GDOT District 3 - Thomaston
Monroe County
SR 18 @ SR 87 Intersection Improvements

SUBJECT APPROVED CONCEPT REPORT

PROJECT CONCEPT REPORT

Roundabout at State Route 18 / Dames Ferry Road and State Route 87

2034 DESIGN YEAR BUILD
AM AND PM PK HR
TRAFFIC VOLUMES

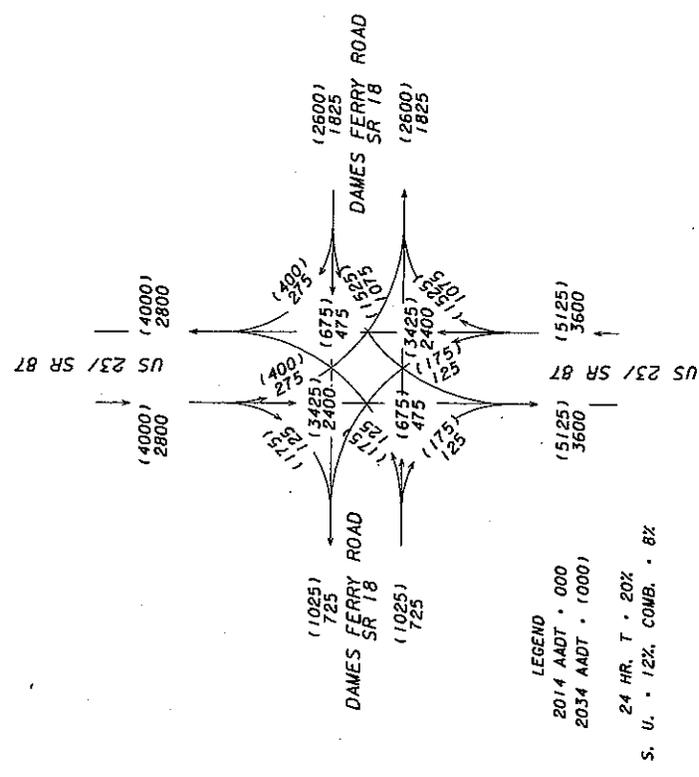
8. **Capacity analysis & Roundabout Analyses:** Please provide a traffic diagram for design and build years.
See Concept attachment for traffic diagrams.
